*LIGO Laboratory / LIGO Scientific Collaboration*

E1300634-v6

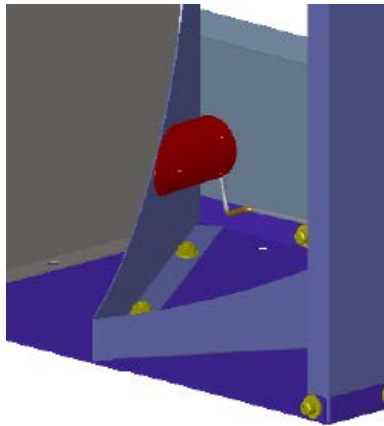
7. Lay Assembly down
8. Attach “SLC Arm Cavity Baffle Center Skin” D1000976 and “Arm Cavity Baffle Center, Mirror Skin” D1101796 to “SLC Arm Cavity Baffle Bottom Skin” D1000975 and “Brace, Lifting, Arm Cavity Baffle” D1101427. Refer to **D1200656 for X-Arm or D1200653 for Y-Arm** assembly drawing for clarification.
  - a. Install hardware 6 places
  - b. Round Holes (screw, SSTL, Brace, washer, nut)
    - i. FA-2412-NA, Flat Head Screw #10-24 X 3/4”L, SSTL - oxidized, Qty 6
    - ii. 98019A330, Flat #10 Washer, SSTL, Qty 6
    - iii. N-1024-A, Hex Nut #10-24, SSTL - Silver Plated, Qty 6
